CITY PLAN COMMISSION

FILE NUMBER: PLAT-25-000104 (S245-249)

REQUEST: An application to replat a 1.447-acre (63,017-square foot) tract of land containing part of City Block 31/8617 to create one 0.353-acre (15,376-square foot) lot and one 1.094-acre (47,641-square foot) lot on property located on Ann Arbor Avenue, west of Cranfill Drive.

1:2,400	<p>EXISTING AREA ANALYSIS MAP</p> <p><input type="checkbox"/> Area Of Request <input type="checkbox"/> Recent History</p>	<p>Case no: PLAT-25-000104</p> <p>Date: 10/06/2025</p>
--	--	--

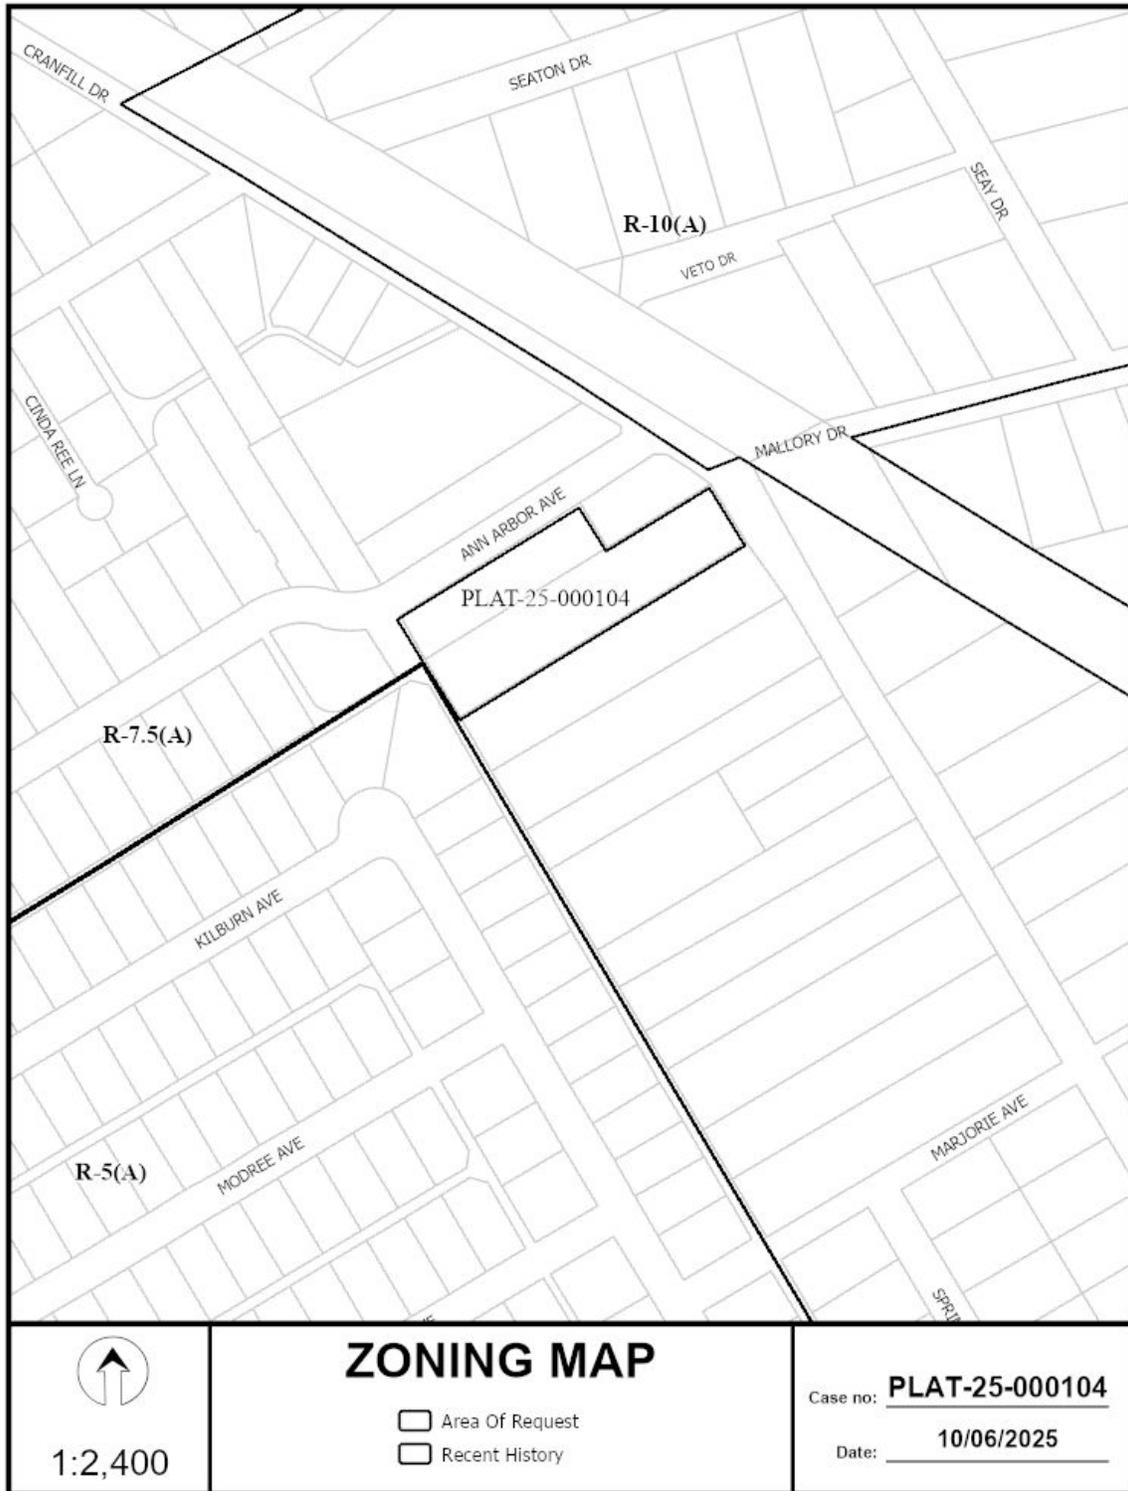
- The properties to the north, south and west have areas ranging in size from 13,046 square feet to 60,317 square feet and are zoned R-7.5(A) Single Family District. (*Refer to the existing area analysis map*)
- The properties to the west have areas ranging in size from 6,721 square feet to 14,954 square feet and are zoned R-5(A) Single Family District. (*Refer to the existing area analysis map*)
